Memorandum

To: Town of Philipstown Planning Board
From: AKRF, Inc.
Ronald J. Gainer, PE, PLLC, Planning Board Engineer
Date: October 20, 2021
Re: Hudson Valley Shakespeare Festival (HVSF) Project
cc: Steve Gaba, Planning Board Attorney
HVSF Applicant Team

FEAF PART 3**II. Project Summary**

REFER TO COMMENT #49

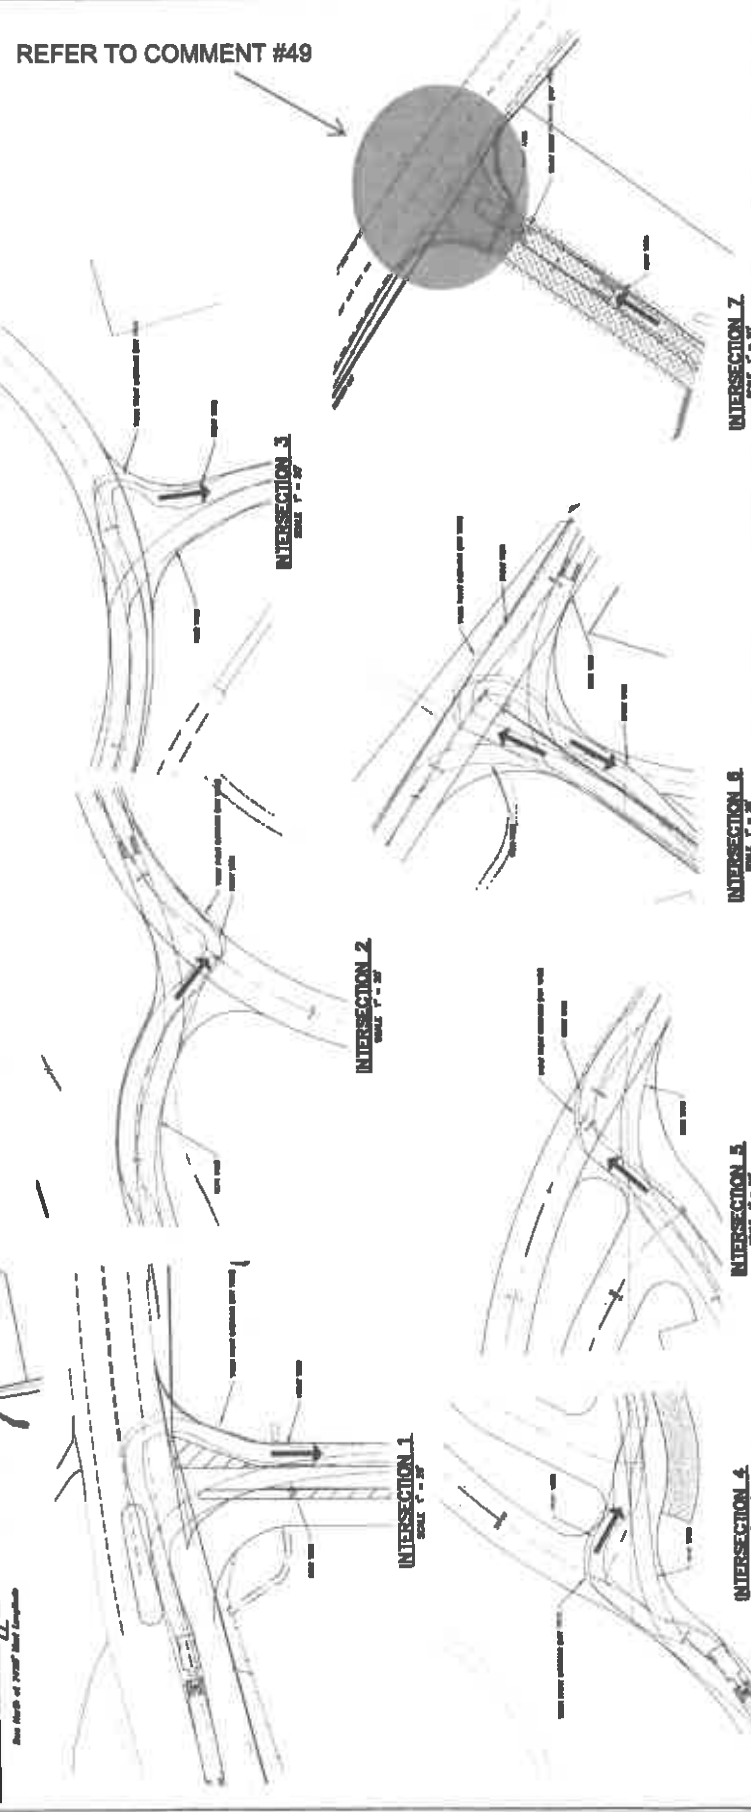
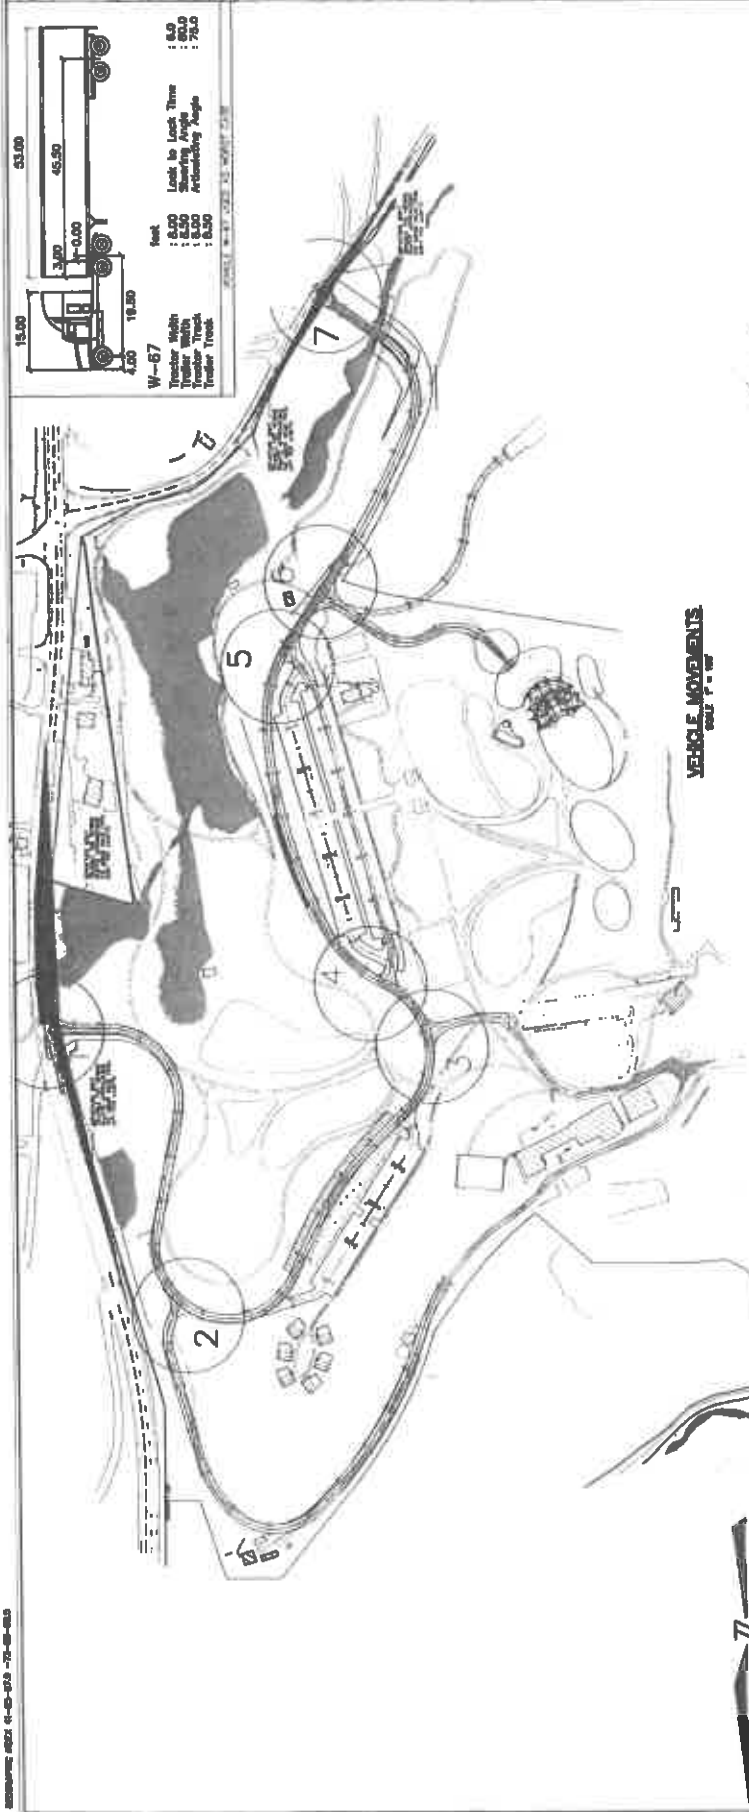
The revisions made to the TIS partially address this comment. The turning maneuvers at Location 7 from the driveway onto Snake Hill Road (see attachment, highlighted in red) are incomplete and need to be shown.
